West Winder Bypass
CSSTP-0006-00(327), P.I. No. 0006327
Barrow County

Value Engineering Study Report

April 2010

ALTERNATIVE NO.: 9

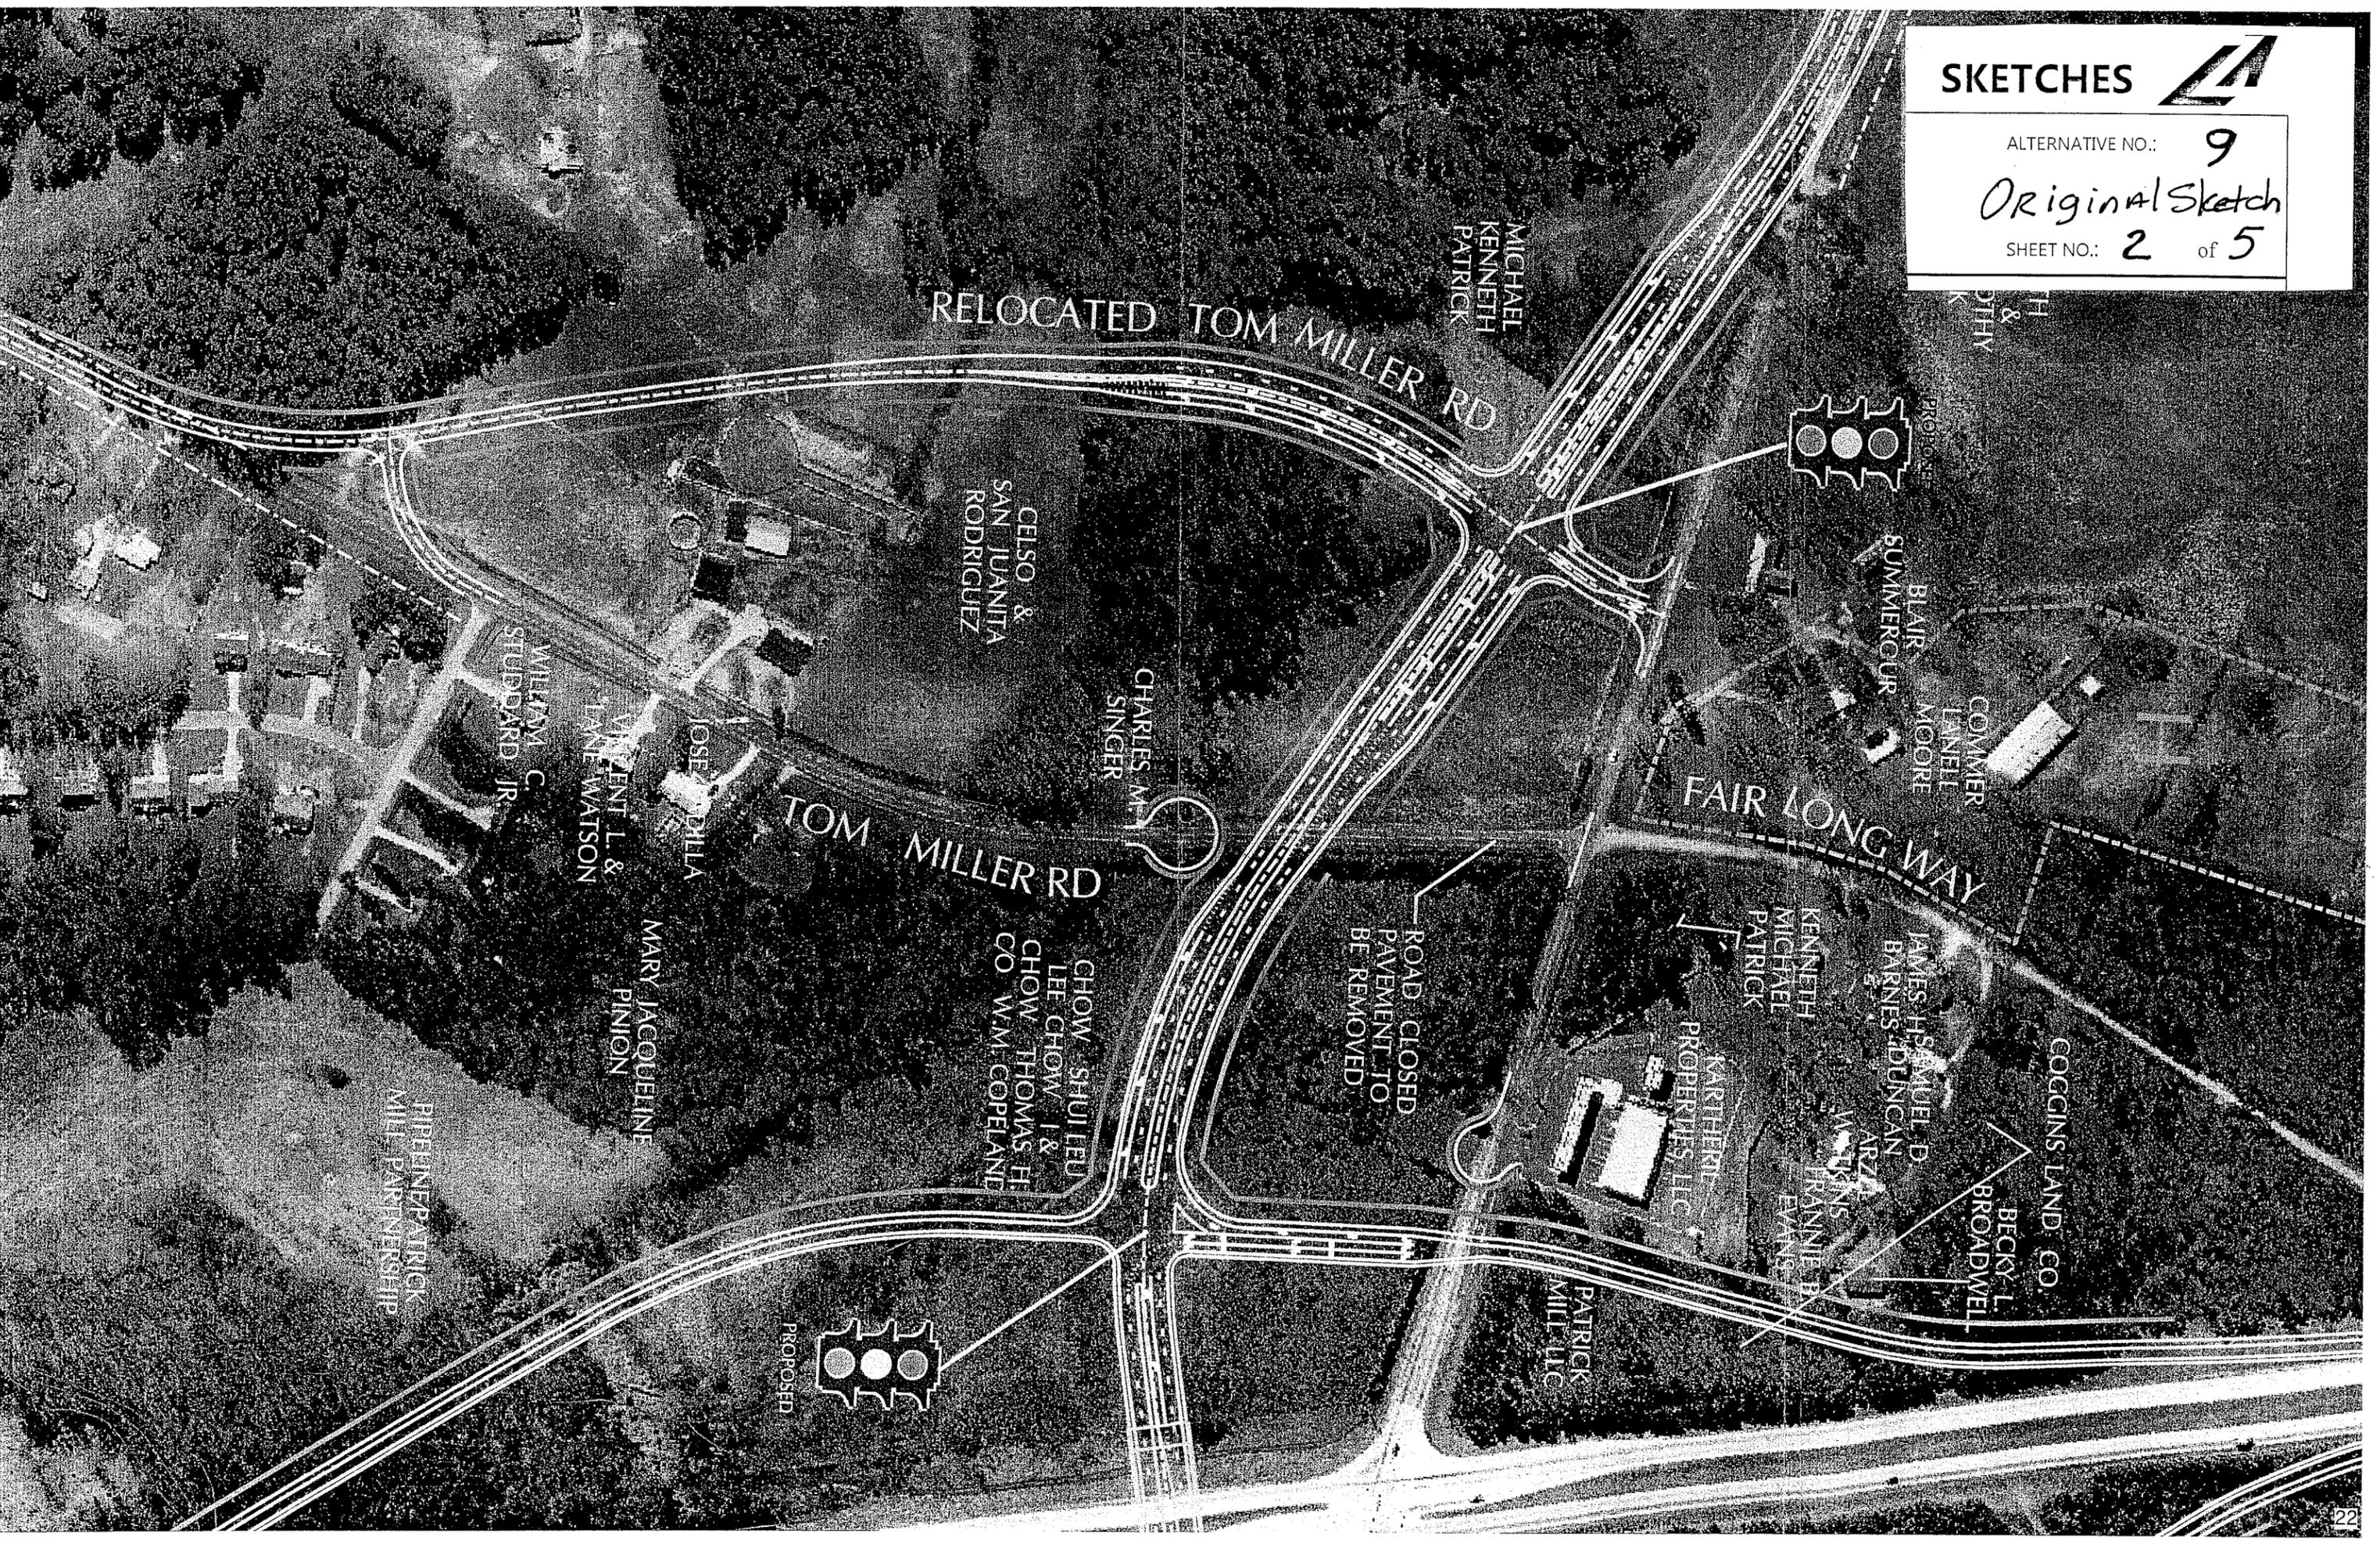
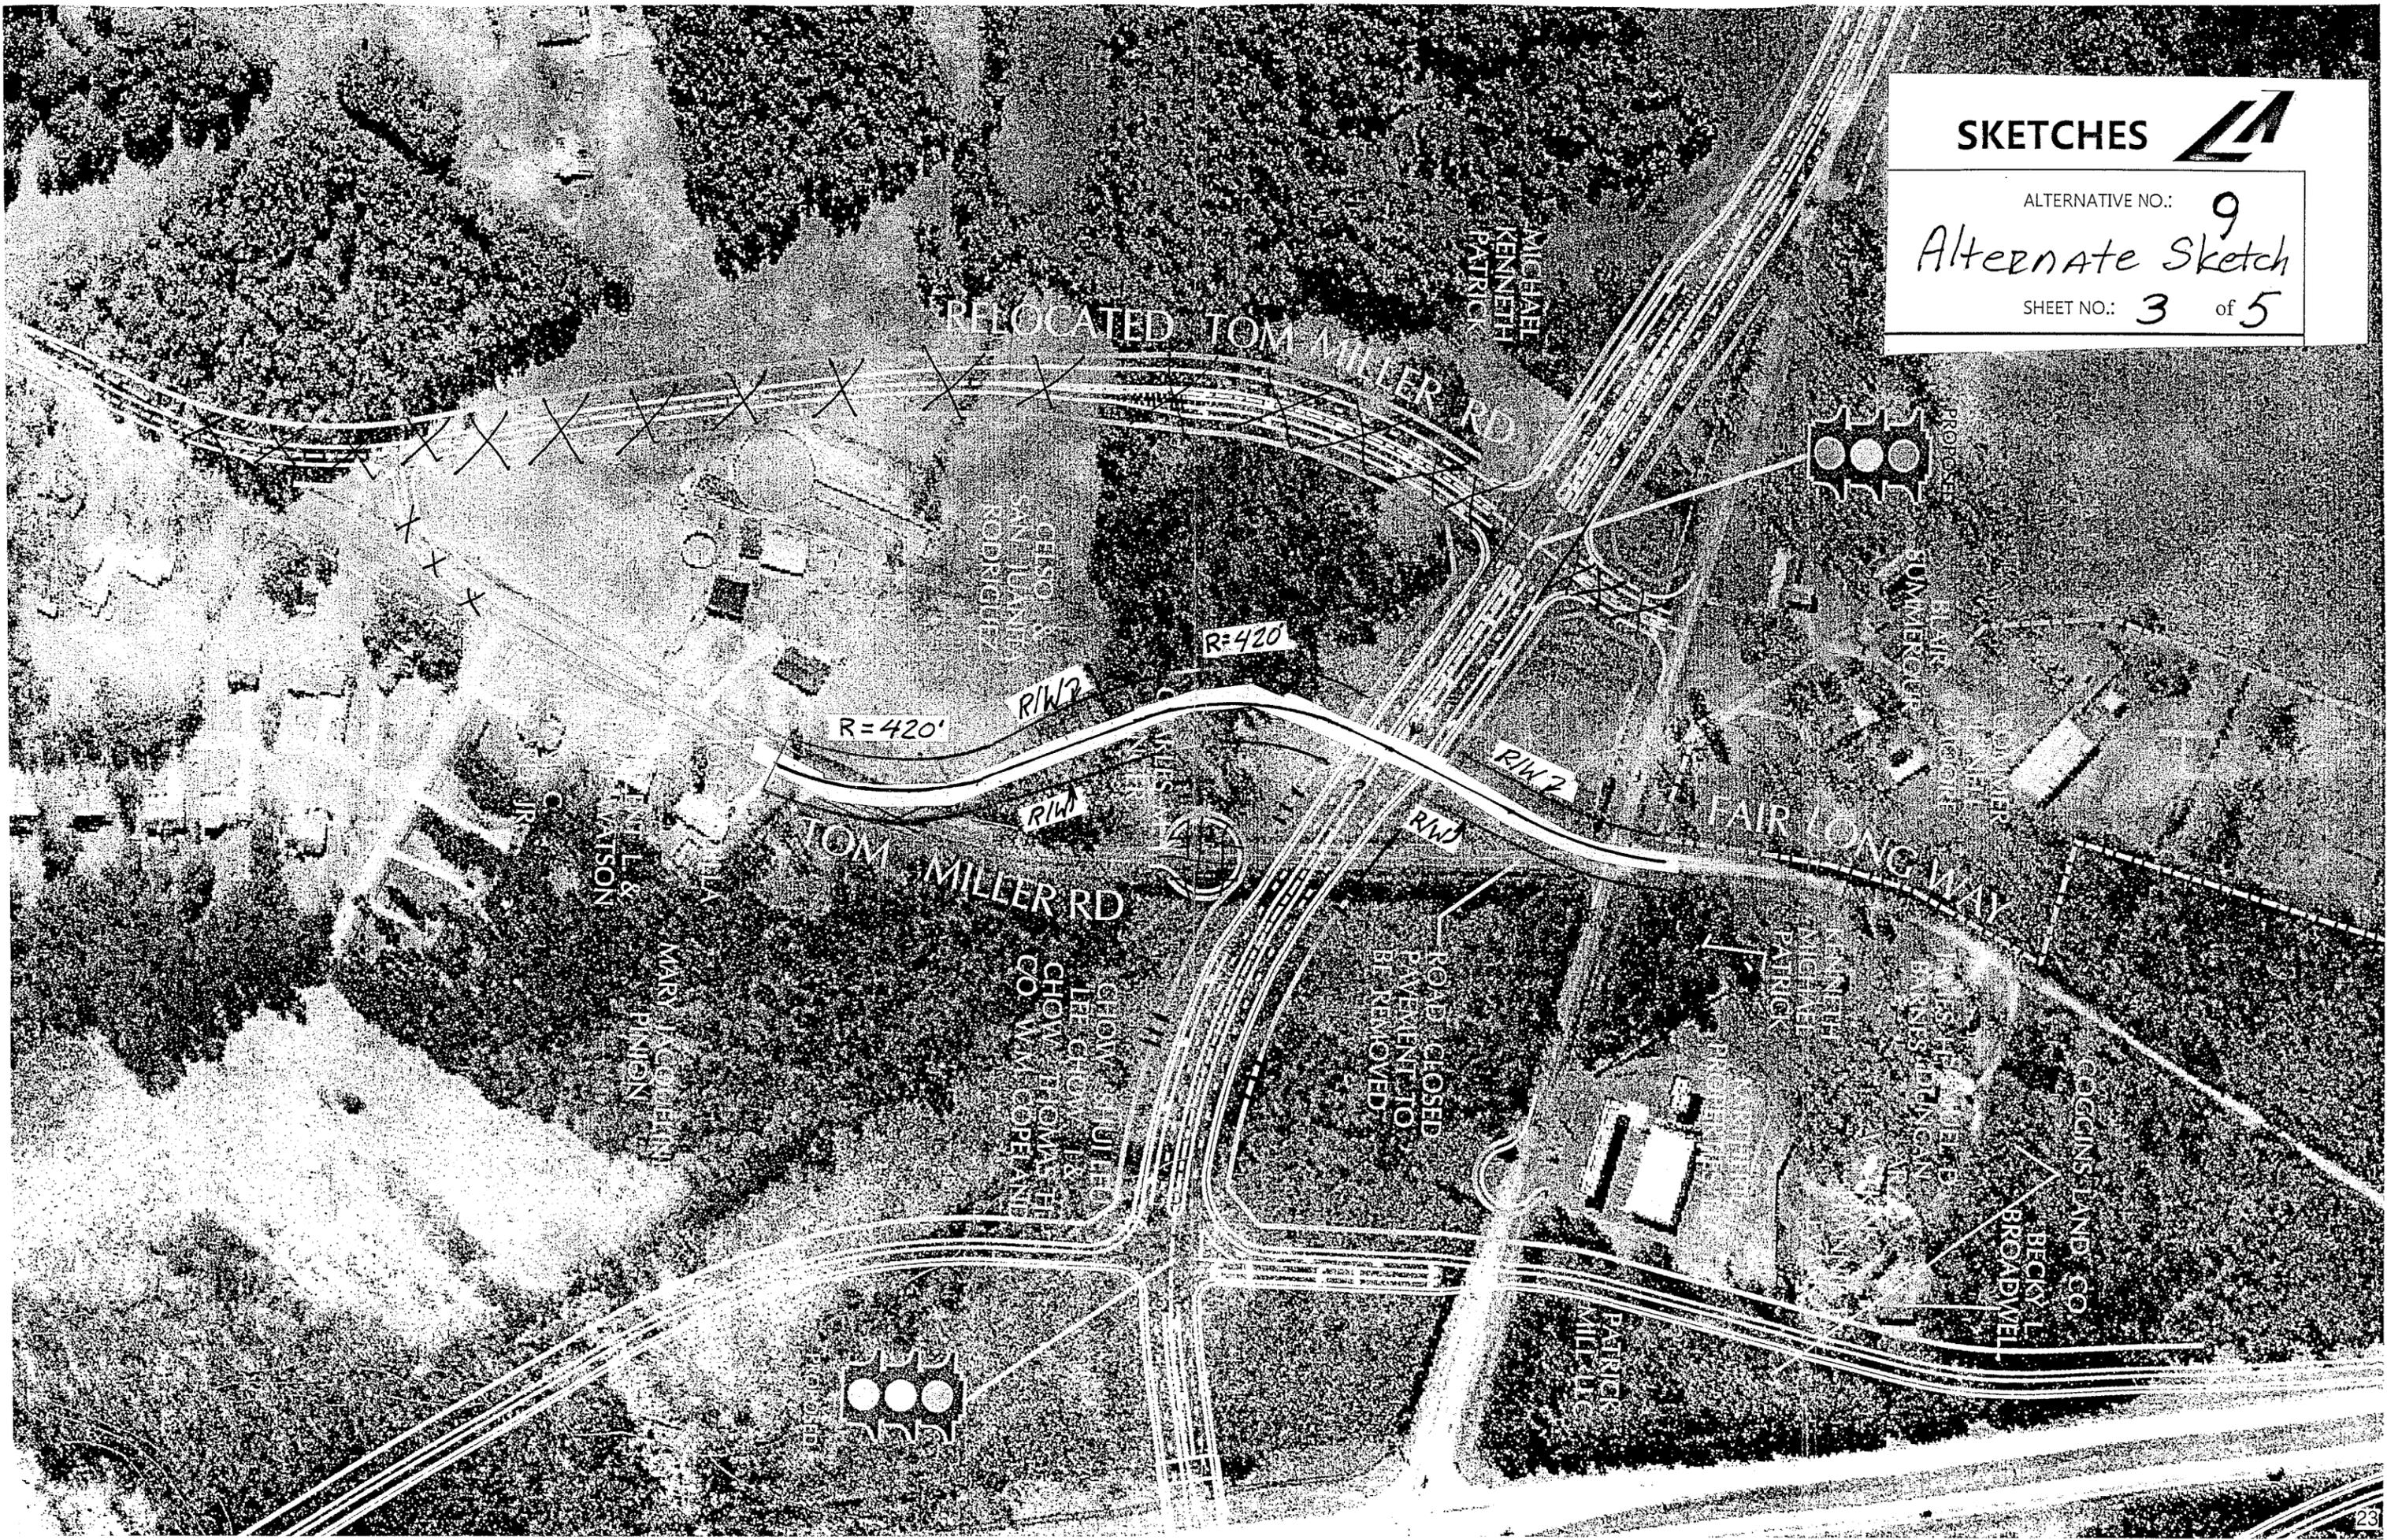
The alternate design would shorten the realignment by 1,200 ft. +/- (2,450 ft. vs. 1,250 ft.) placing the median opening for Tom Miller Road 800 ft. from the adjacent ramps intersection. It is recommended that limit of access rights be acquired from the ramps to the new median opening for Tom Miller Road/ Fair Long Way because the desirable distance for the first median opening from the ramps is 1,000 ft. However, limiting the access along Patrick Miller Road would help mitigate the shorter distance between median openings. The realigned road design speed is 35 mph which is not a problem since traffic approaching the intersection will be decelerating to turn left or right onto Patrick Miller Road. Also, there is very little through traffic on Tom Miller Road since Fair Long Way is a dead-end road.

Alter nate Design
≠ ORIGINAL Design
Sketch
Alt. 12

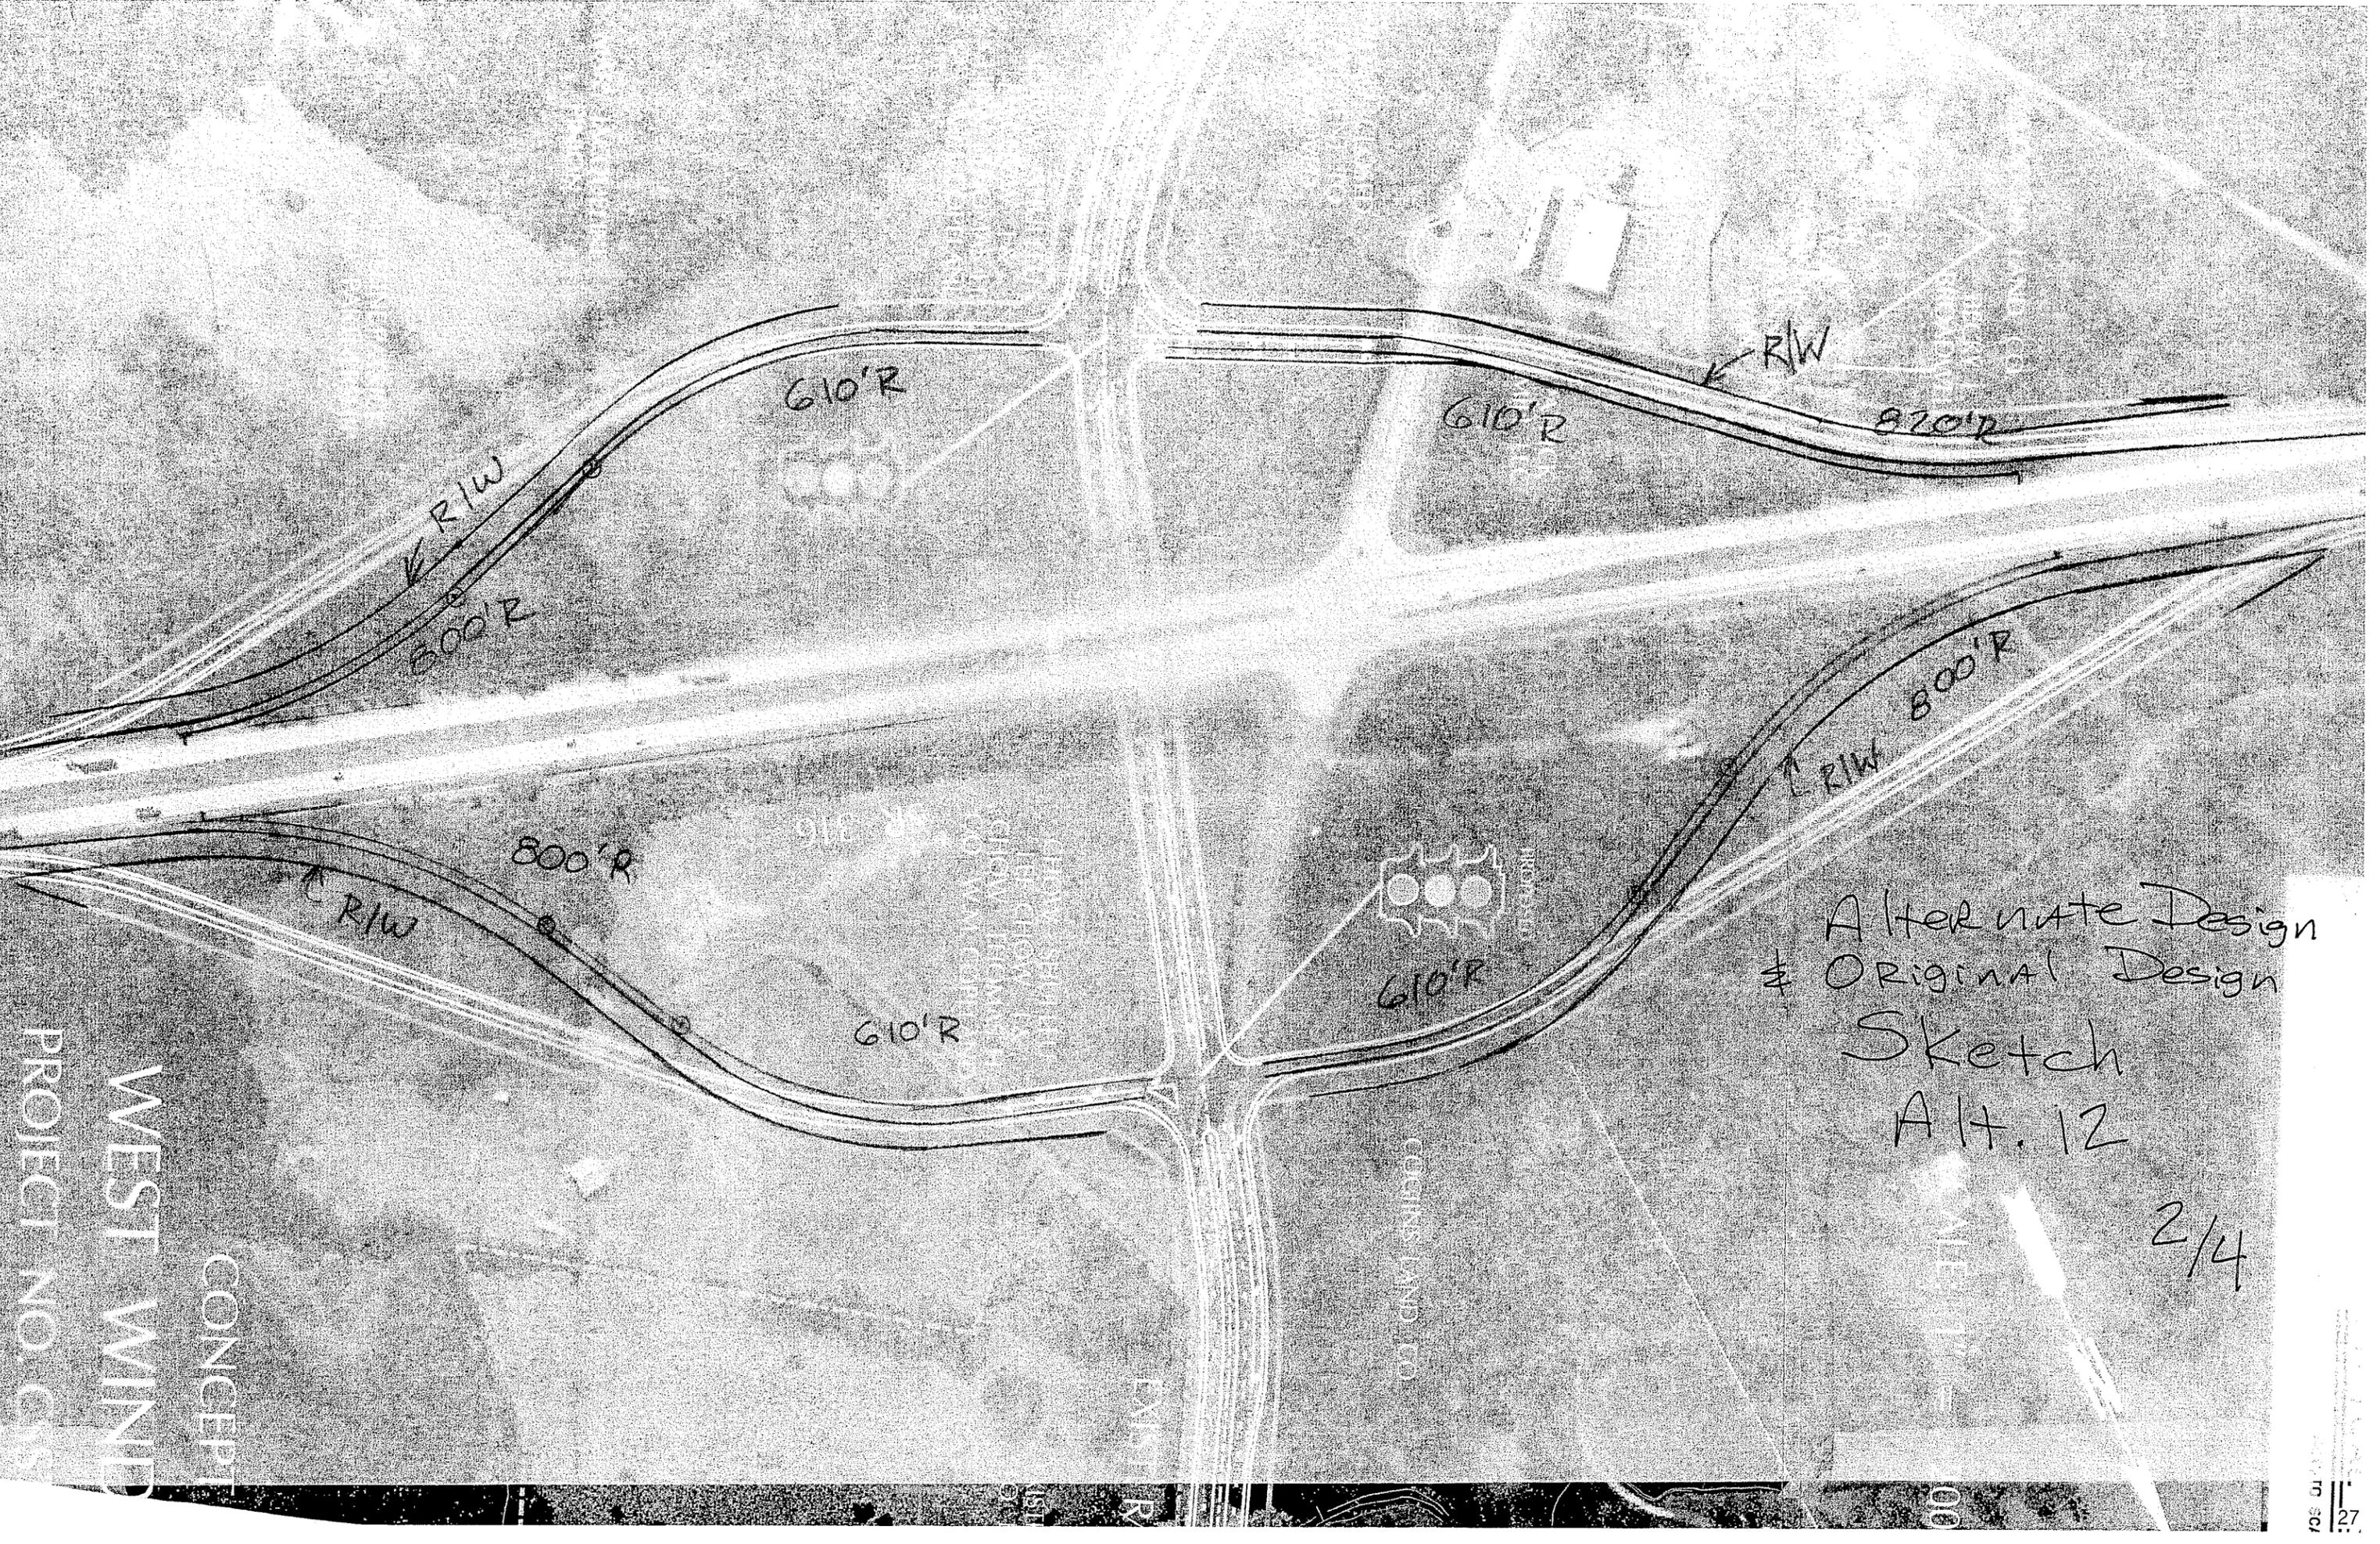
The current ramps are longer than is desirable by AASHTO guidelines which is 1,200 ft. (see Freeway design for diamond interchanges in the "Greenbook"). The shorter lengths will save both construction and right-of-way requirements.
